Subject: Draft 1 Version 8 ENERGY STAR® Television Specification

This letter comprises the comments of the Pacific Gas and Electric Company (PG&E), Southern California Gas Company (SCGC), San Diego Gas and Electric (SDG&E), and Southern California Edison (SCE) in response to the updates proposed in the Environmental Protection Agency (EPA) Draft 1 Version 8 ENERGY STAR Television Specification.

Source: ENERGY STAR Television Test Dataset, October 2016

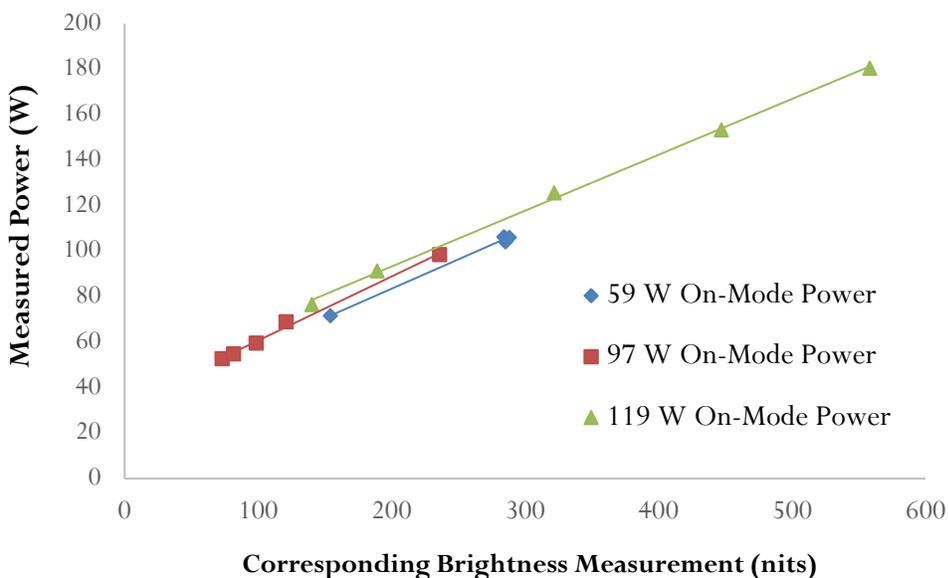
The above figure shows how three different 55-inch UHD models can exhibit very similar power draw profiles, but report drastically different on-mode powers due to different brightness and dimming levels. In reviewing available data, ABC settings are the largest reason for variations in reported on-mode power.

We support EPA’s proposal of limiting the conditions where ABC, an energy savings feature, can be automatically disabled without the consumer knowing if the television is certified with the ABC feature enabled and taking advantage of the ABC allowance as provided in the test procedure. We ask EPA to go one step further and require that ABC not be automatically disabled in all preset picture settings⁶ in order for televisions to be certified with ABC enabled by default. This provision would close any loopholes and ensure the persistence of this energy savings feature in modes commonly used by viewers. Given that multiple major manufacturers, such as LG, Sony, and Phillips, are able to implement ABC in all preset picture modes, there is no technical reason or picture viewing limitation for not implementing ABC properly in **all preset modes**.

Source: California Energy Commission Appliance Database , October 2016

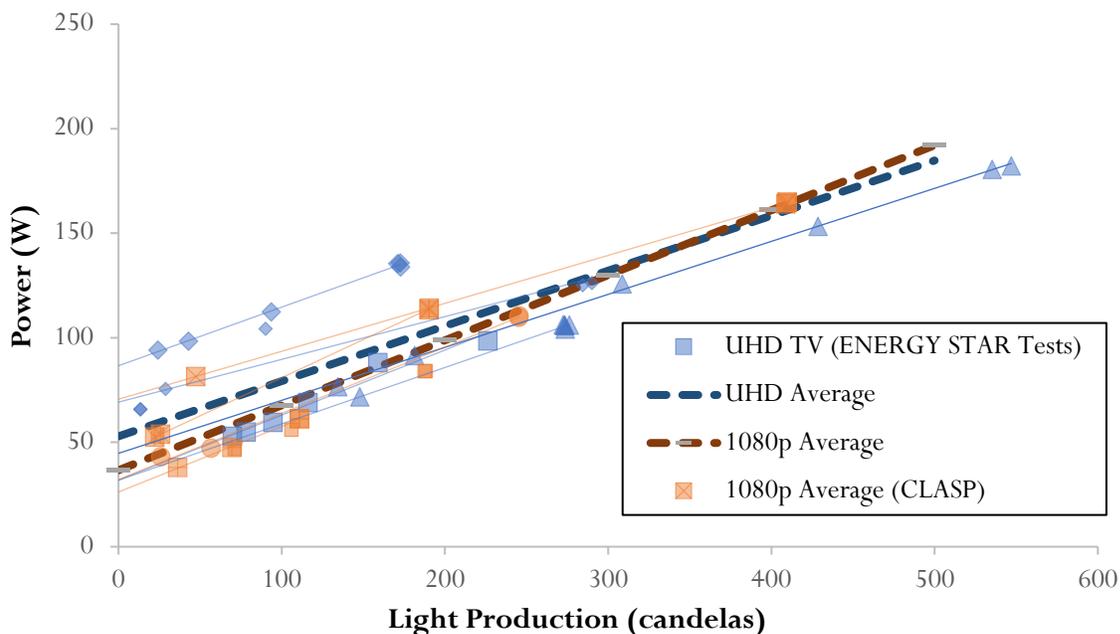
From ABC measurements performed by ENERGY STAR and CLASP, power-light output curves can be plotted for several UHD and 1080p TVs. ENERGY STAR tests used 55-inch UHD models manufactured in 2015 or 2016. The CLASP tests used 1080p direct-lit LED models considered to be new when the report was released in 2011. These tests separately report each measured on-mode power of TVs at various brightness settings, which was determined by the TV in response to ambient light conditions since ABC was enabled. It is worth noting that the resulting data does not show true efficacy, but instead shows the on-mode power, tested using the IEC test clip, at various settings that produce a certain brightness when tested using the 3-vertical-bar broadcast signal. However, since all TVs were tested this way, the curves are comparable. The figure below shows the curves plotted and averaged by UHD/1080p.

The slope for UHD TVs was found to be less than that of 1080p TVs. This is interpreted to mean that UHD TVs produced in 2015 or 2016 have more efficient backlights, or dimming techniques, than 1080p TVs produced in 2010 or 2011. However, the intercept for UHD TVs suggests an increased computing power (expected for higher resolution). The difference of the intercepts is about 16 watts.

An assessment of the televisions listed in the CEC Appliance Database shows that UHD models on average produce 23 candelas more light (about 20 nits more) than their 1080p counterparts, which equates to about 6 watts of power. If UHD TVs are designed to be operated at higher brightness levels, as evidenced by their default settings, **this analysis suggests a flat UHD adder of 22 watts** is more appropriate than a percentage that scales with power.

Therefore, we recommend EPA consider updating the UHD power allowance, if not in Version 8 due to time and scope constraints, then most certainly in the Version 9 specification. If the timeline for the Version 8 process is extended for any reason, the UHD power allowance update should be included in the scope since data analysis is available to support a significant reduction.
